**Request for authorization to return
Pickering Nuclear Generating Station
Unit 5 to service, following its current
forced outage**

Pickering NGS: OPG responses to CNSC staff inquiries related to OPG's request for expedited authorization to restart following the Pickering Unit 5 2021 fall forced outage

OPG Responses to CNSC Questions regarding OPG's September 29th Submission (NK30-CORR-00531-08328)

OPG Responses to CNSC Questions regarding OPG's October 1st Request for Expedited Authorization to Restart Following Pickering Unit 5 2021 Fall Forced Outage

**Fuel Channel Assemblies
Shield Plug Assembly**

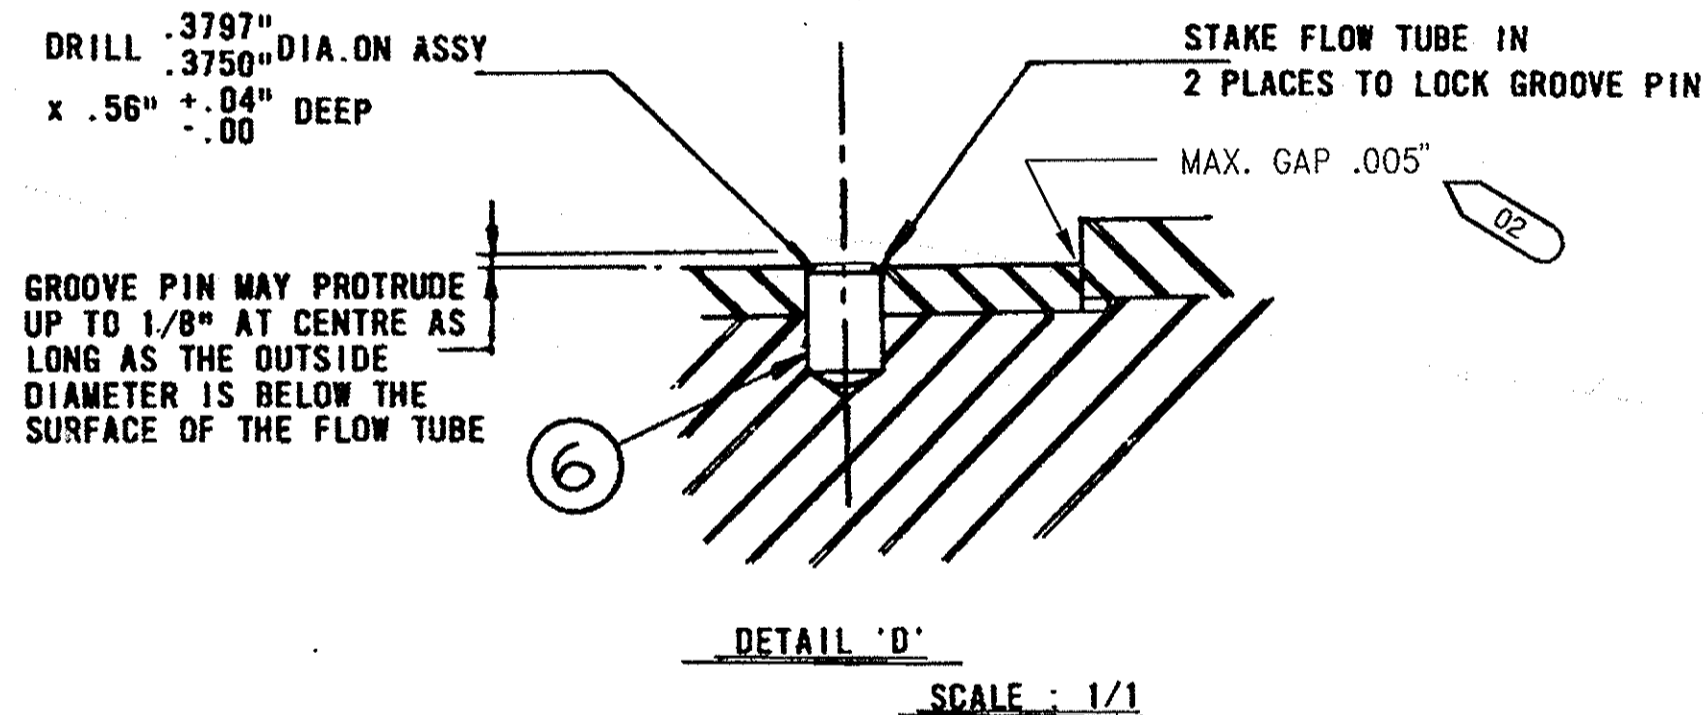
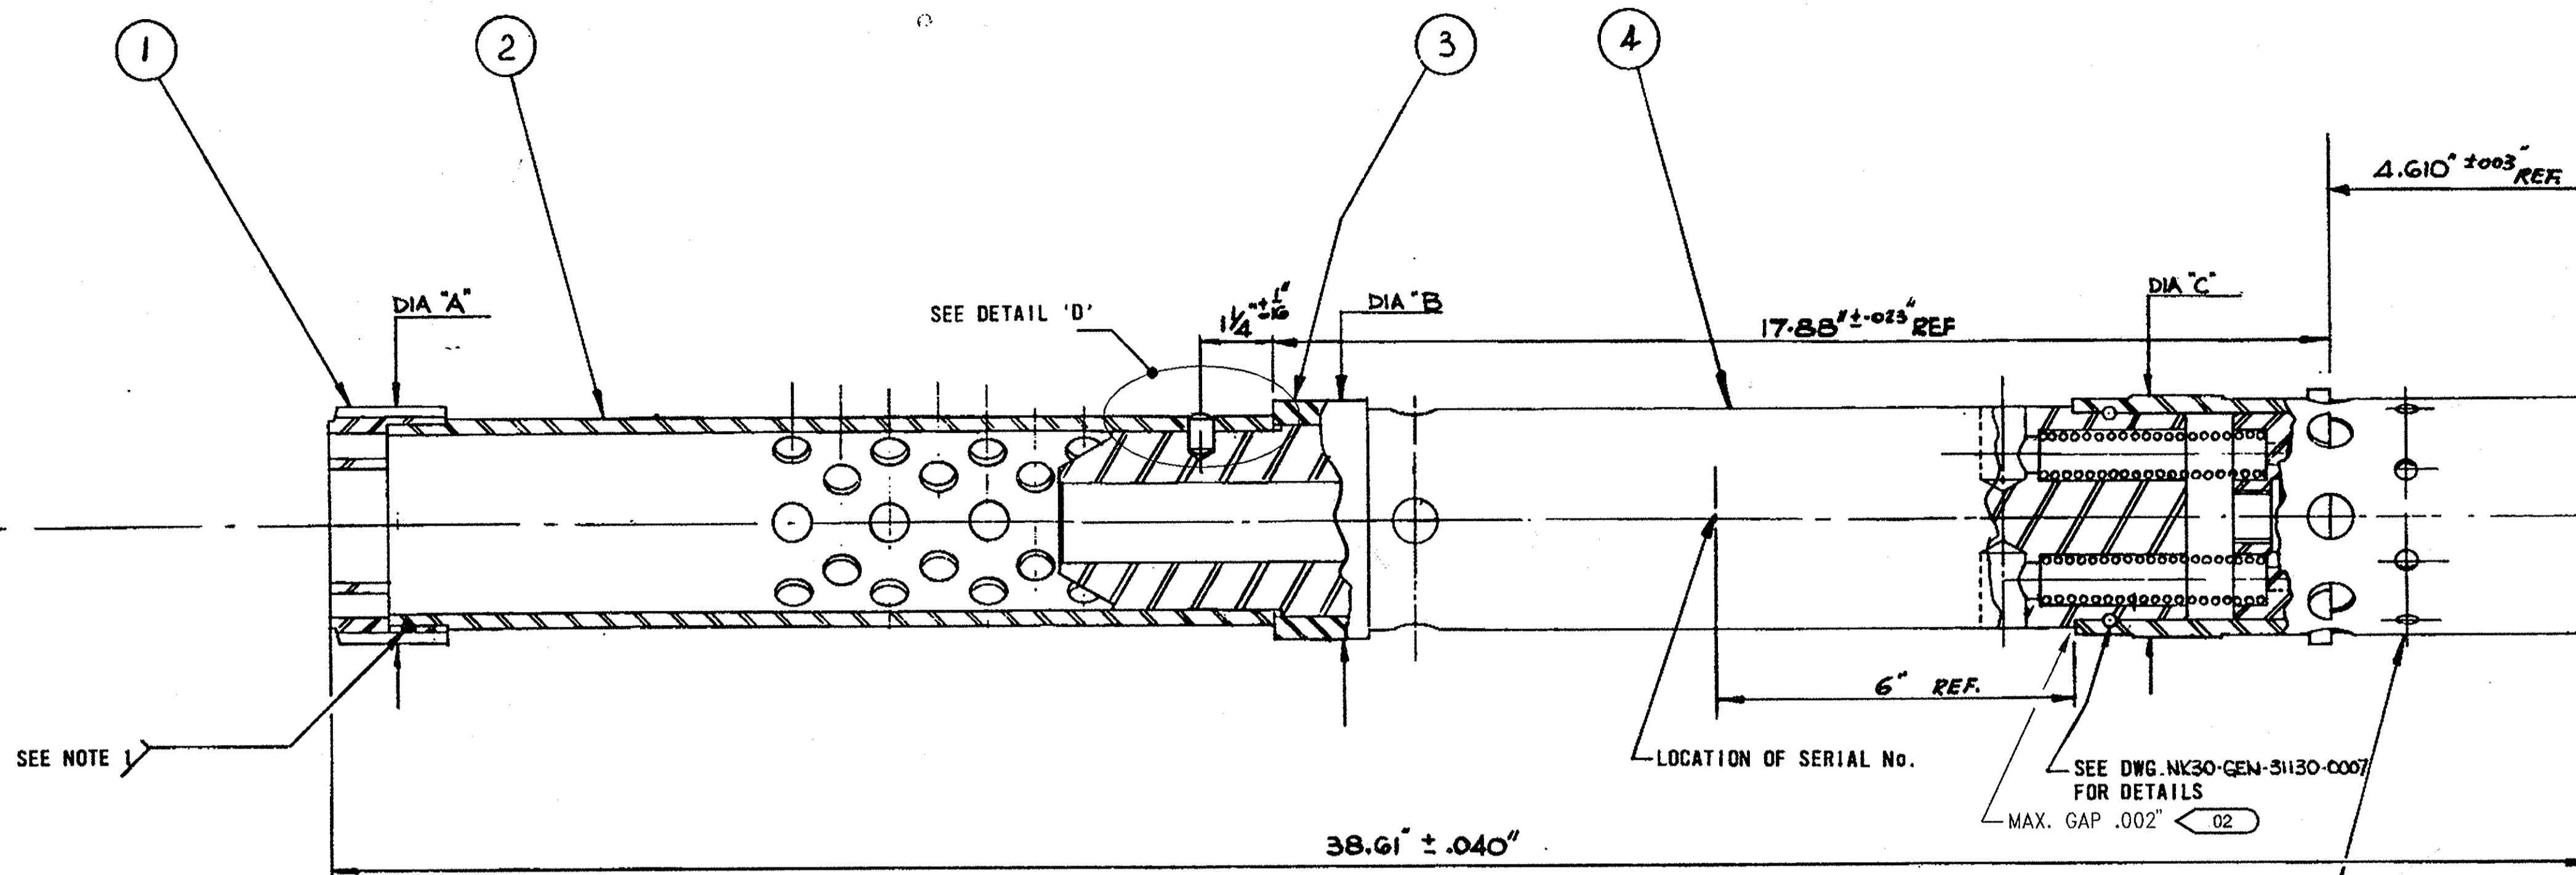
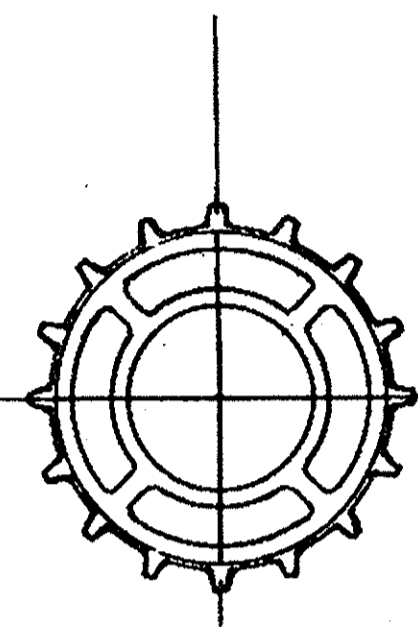
A description of the configuration of the shield plug in Pickering B reactors and particularly in Unit 5 and how those two dispositionable flaws could be formed in the region of interest given there are no fuel bundles there, only the shield plug.

Staff understand that the shield plug covers the location of P5005- IND 1 flaw. If this is correct, OPG is requested to clarify how can a debris get struck between the shield plug and Pressure tube and formed a flaw? What is the typical gap between the shield plug and pressure tube?

The configuration of the P5-8 shield plug is shown per the attached documents:

- P5-8 Shield Plug Assembly (See Attachment 2 - NK30-GDN-31130-0001-001)
- P5 Fuel Channel Assembly (See Attachment 3 - NK30-GEN-31100-0004-U5-0001)

Although infrequent, when fuel with entrained debris interacts with the bottom of the pressure tube during fuelling, it is possible for flaws to form (only 2 debris flaws have been discovered in this area from 225 unique pressure tube inspections).

Yes, the shield plug does cover this location. It is possible that this flaw is a scratch that was formed due to debris stuck in fuel bundles during fuelling operations or in a rare occurrence, early in life where a potential debris was caught in the shield plug. However, the clearance between the shield plug and the pressure tube is very minimal. Note that the actual cause of this flaw (i.e. scratch or debris) cannot be confirmed, however for the purposes of pressure tube fitness for service, it has been assessed conservatively as a debris fret. There is a very low likelihood of debris flaws forming in this region as the last fuel bundle rests against the outlet shield plug, which resides nominally ~85 mm inboard of the burnish mark. OPG has a robust Foreign Material Exclusion (FME) program which is demonstrated by the low number of debris fretting in our units
